HOLDOVER
REVISED
BUD MATHIS SUBDIVISION

BUD MATHIS SUBDIVISION

APPLICATION NUMBER Holdover DATE July 24, 2003

DETAIL SITE PLAN

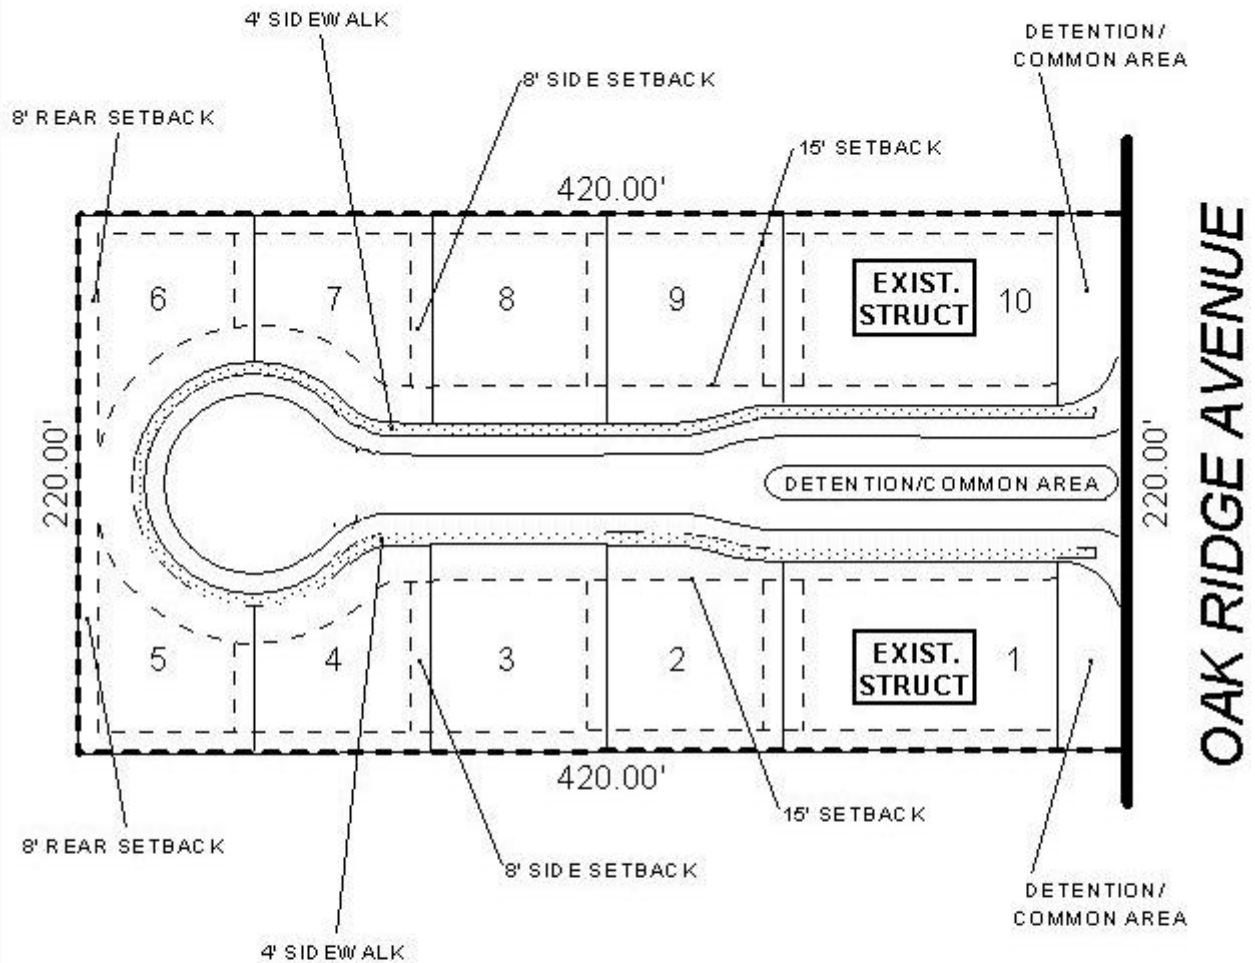
In order to provide adequate traffic management, Lots 1 & 10 should be denied direct access to Oak Ridge Avenue.

The typical lot size as illustrated on the preliminary plat does not meet the minimum lot size as required by the Subdivision Regulations. Additionally, the subdivision as proposed does not fall under the Innovative Design Section of the Subdivision Regulations, which allows reduced lot widths and lot sizes, nor does the overall development maintain the density standards of the Subdivision Regulations (7,200 square foot per lot).

The applicant submitted a revised plan further reducing the overall area from approximately 69,224 square feet to 63,306 square feet. The overall area excluding streets, does not meet the minimum lot size (7,200 square feet) as required by the Subdivision Regulations. The applicant submitted the documentation (deed prior to 1984) required illustrating that the remainder of the property is a legal nonconforming lots of record. Furthermore, no documentation was submitted to illustrate that the subdivision will consist of innovative design elements as outlined in Section VIII.C. of the Subdivision Regulations.

*Based upon the preceding, this application is recommended for denial for the following reason:
1) the plat contains lots that would not meet the minimum lot area requirements of the Subdivision Regulations.*
